## LAN8740A/LAN8740Ai Silicon Errata and Data Sheet Clarification

This document describes known anomalies for functional revision A and B of the LAN8740A/LAN8740Ai device. The functional revision can be determined by its top marking as indicated in [Figure 1](#) and [Figure 2](#).

**FIGURE 3: EXAMPLE EXTERNAL CRYSTAL CIRCUIT**

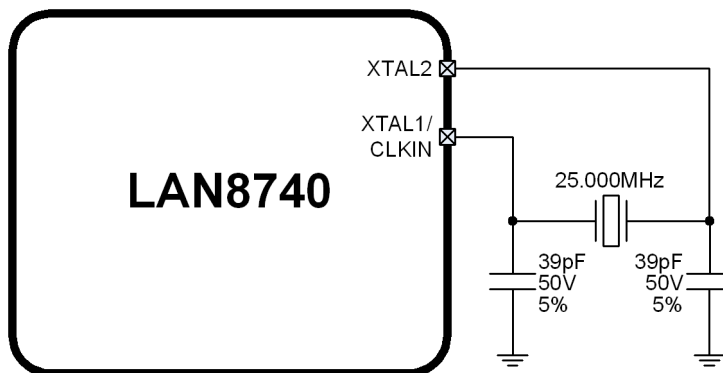
In IEEE mode, the device may drop link when using a Broadcom BCM53125 link partner at cable lengths less than 20 meters.

When using a Broadcom BCM53125 link partner in IEEE mode, the device may drop link when using cable lengths less than 20 meters. The BCM53125 has exhibited a sensitivity to minute deviations in its link partner's transmit clock frequency during 100Mb IEEE operation. This issue is exacerbated at short cable lengths. This anomaly does not impact 10Mb or non-IEEE operation.

1. Utilize an Ethernet cable length of greater than 20m.
2. Increase the load capacitors on the LAN8740A/LAN8740Ai external crystal circuit to 39pF and exercise best practices for board layout. Refer to [FIGURE 3](#): for an example external crystal circuit.

3. Use a single-ended 25MHz clock source that meets the LAN8740A/LAN8740Ai specification requirements in lieu of a crystal.
